High Speed Rail in the Chilterns

Part 3: CRAG Proposal

Explanatory note

In response to a proposals by petitioners in the Chilterns, and in response to petitions against the High Speed Rail (London – West Midlands) Bill, a number of options for a tunnel or tunnel extension in the Chilterns have been evaluated by HS2 Ltd.

Figure 1 – Indicative route for 11kV power supply

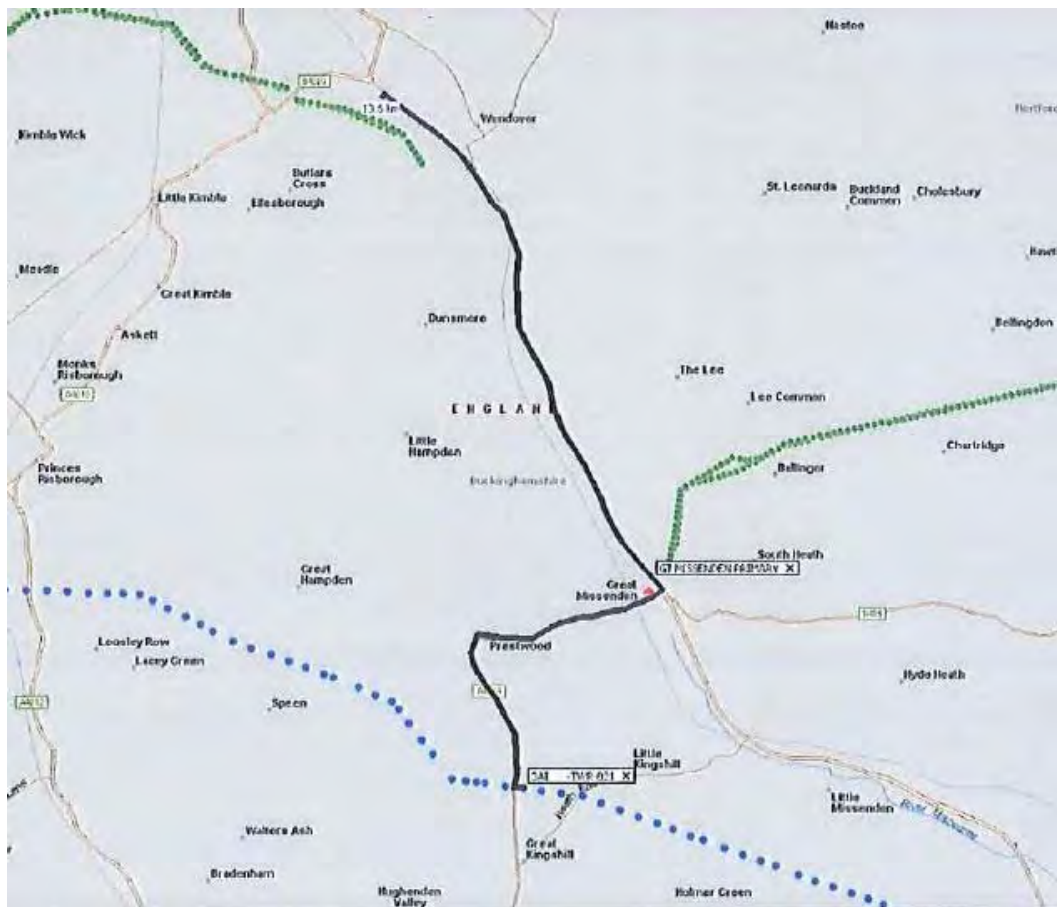
4.6.5 During construction an additional 11kV power supply would need to be routed from the national grid to run the TBM's from the north portal. It is likely that the route of the underground supply would be approximately 14km long in order to connect to an appropriately sized supply, and would follow the A4128 from Prestwood to Great Missenden then along the A413 to the north portal (refer to Figure 1 below). The anticipated lead-in time is three to five years. The information provided is indicative only at this stage.

4.6.6 There is likely to be engineering difficulty at railway crossings and major roads which have not been fully factored in to the costs of this power supply.
